HN-234.1*
DN-181.1*
EN-73.1*
FN-60.1*

SERVICE BULLETIN

DATE: 10 SEPTEMBER 1992
PAGE 1 OF 4

INSPECTION/REWORK OF FUEL VENT SYSTEM

Figure 1. Inspection/Rework of Fuel Vent System.

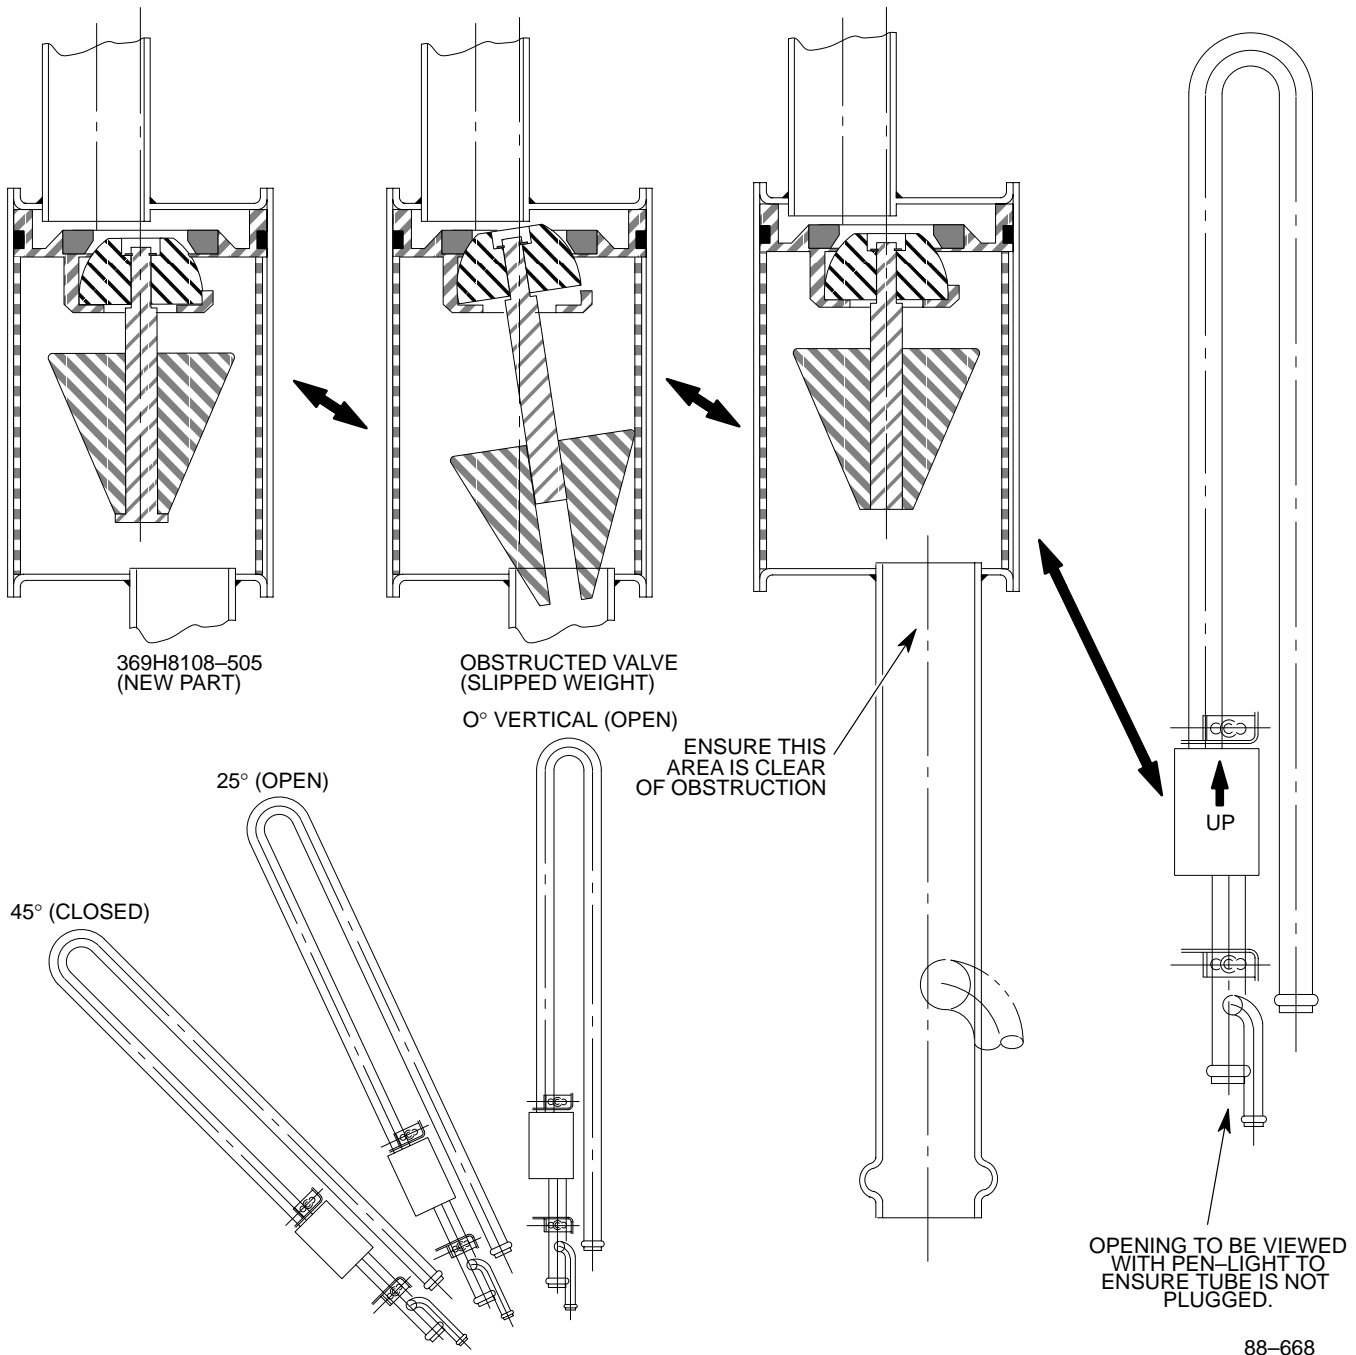
- c. Holding the vent tube in an upright position (0 deg. vertical), inspect tube opening shown in Figure 1 using a pen-light. Ensure tube is not obstructed. Replace any obstructed vent/tube assemblies with a 369H8108-505, 369H8108M, 369H8108-501M or 369H8108-503M vent/tube assembly.

369H8108-505 fuel vent line emergency shutoff valves have an improved valve weight attachment design which will not allow the weight assembly to slide down the shaft that it is mounted on thus preventing the valve weight from obstructing the fuel vent system (see Figure 1). The 369H8108M, 369H8108-501M and 369H8108-503M have been modified to incorporate the improved weight attachment design.

- a. Remove the vent tube emergency valve assembly per the applicable maintenance manual.
- b. Inspect vent tube emergency shutoff valve for condition. Valve should be open when held vertical. Valve should be closed when held in the 45 deg. from vertical position. While held in the 45 deg. position blow in the valve assembly and check that valve is closed. Valve shall open when returned to the 25 deg. position from the 45 deg. position. Replace obstructed assemblies with a 369H8108-505 assembly or reworked 369H8108M, 369H8108-501M or 369H8108-503M.

- a. Remove 369H8108, 369H8108-501 or 369H8108-503 fuel vent line emergency shutoff valve from affected helicopters per the applicable maintenance manual.
- b. Install a 369H8108-505, 369H8108M, 369H8108-501M or 369H8108-503M fuel vent line emergency shutoff valve per the applicable maintenance manual.
- c. Record compliance to **PART II** in the compliance record section of the helicopter Log Book.
